# Discussion on “AC Drive Observability Analysis”

**Abstract**—In the paper by Vaclavek *et al.* (*IEEE Trans. Ind. Electron.*, vol. 60, no. 8, pp. 3047–3059, Aug. 2013), the local observability of both induction machine and permanent magnet synchronous machine under motion sensorless operation is studied. In this letter, the “slowly varying” speed assumption is discussed, and the permanent magnet synchronous machine observability condition at standstill is revisited.

Fig. 1. Vector diagram of the fictitious observability vector (dashed).

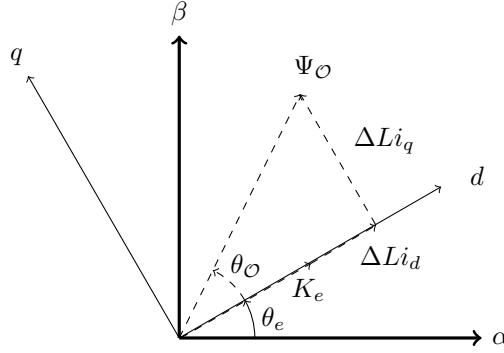
where  $\theta_O$  is the phase of the vector  $\Psi_O$  in the rotating reference frame (Figure 1). The following sufficient condition for the PMSM local observability can be stated:

*Proposition 1:* The PMSM is locally observable if the angular speed of the fictitious vector  $\Psi_O$  in the  $dq$  reference frame is different from the rotor electrical angular speed in the stator reference frame.

At standstill, the above condition becomes: the vector  $\Psi_O$  should change its orientation in order to ensure the local observability. This provides a better formulation of the PMSM observability conditions.

Fig. 2. Vector diagram illustrating two observability vectors that correspond to two stator current space vectors that differ in magnitude and direction.

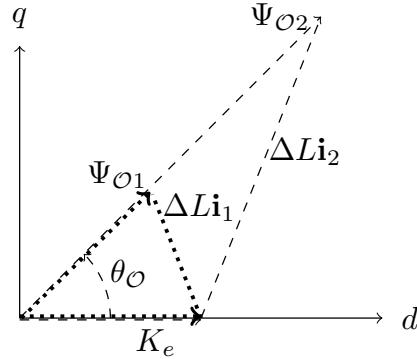
Figure 2 shows two observability vectors,  $\Psi_{O1}$  (dotted) and  $\Psi_{O2}$  (dashed), that correspond to two different (in magnitude and direction) current space vectors:

It is obvious that, contrary to the conclusion drawn in [1] for the IPMSM, at standstill ( $\omega_e = 0$ ), the stator current space vector can change both its magnitude and direction, following the constant- $\theta_O$  trajectory, without fulfilling the observability condition (8). It should be noticed that this is related to the constant  $C$  of the equation (3), which value is judged to be unnecessary in the paper under discussion.
